# Technical Review of Cape Fear River PFAS Loading Reduction Plan for Cape Fear Public Utility Authority (CFPUA)

September 27, 2019

Figure 3. Flow-based PFAS Loading Rate (provided by CFPUA)

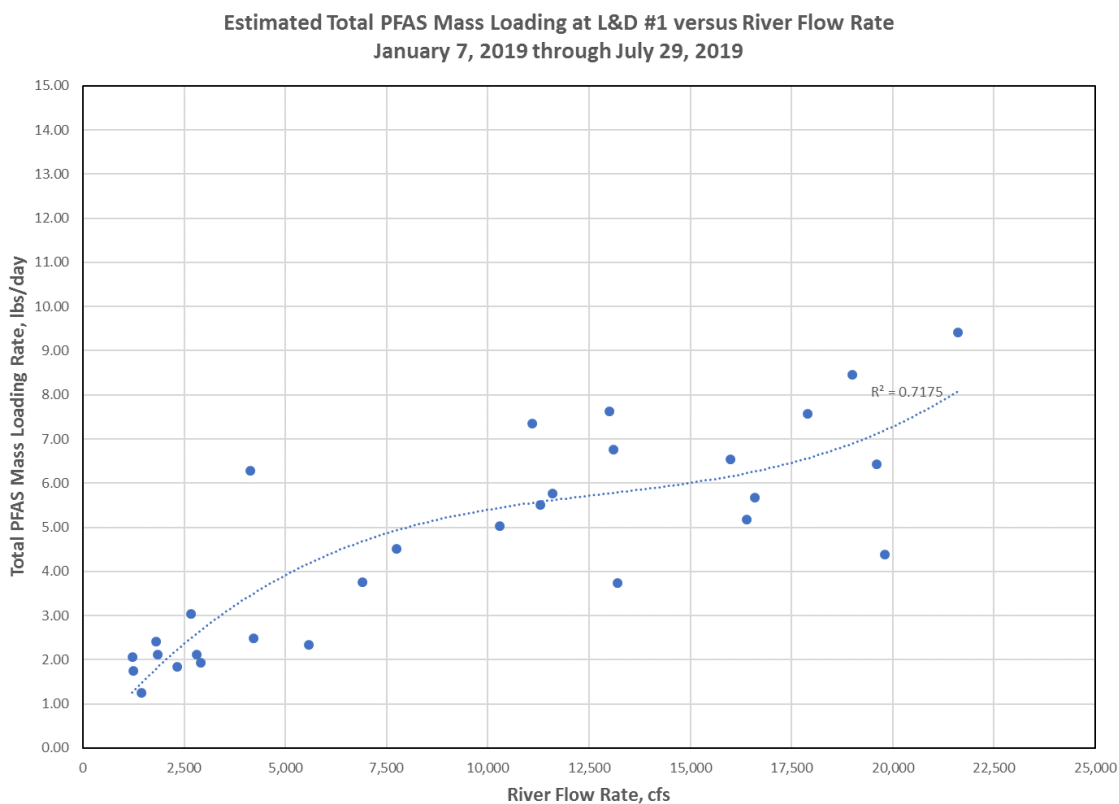
7. A flow-based PFAS loading curve prepared by CFPUA for 2019 is shown in Figure 3. Higher PFAS loads are associated with higher flows, which indicates that stormwater and/or sediment bed erosion (as described in the previous comment) contributes PFAS to the river. Yet, these sources are poorly quantified, including both onsite and offsite stormwater contributions.
